## **Ford Mondeo Model year: from 05.2002**

### **Low-pressure service connection**

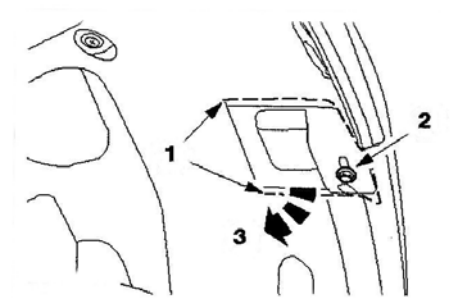
On the above-mentioned vehicles manufactured since 02.05.2002, it is no longer necessary to remove the right-hand wheel house lining to reach the low-pressure service connection.

The modified wheel house lining has a pre-marked maintenance opening through which the service connection is accessible. When the service unit is connected to the low-pressure side for the first time, the maintenance opening must be cut in along the marking. Please proceed as follows:

- Lift the vehicle
- Cut in the wheel house lining carefully along the marked lines (drawing, pos. 1)
- Remove the screw (drawing, pos. 2)
- Open the maintenance opening (drawing, pos. 3)
- Once the maintenance work has been completed, close the opening and screw in the screw.
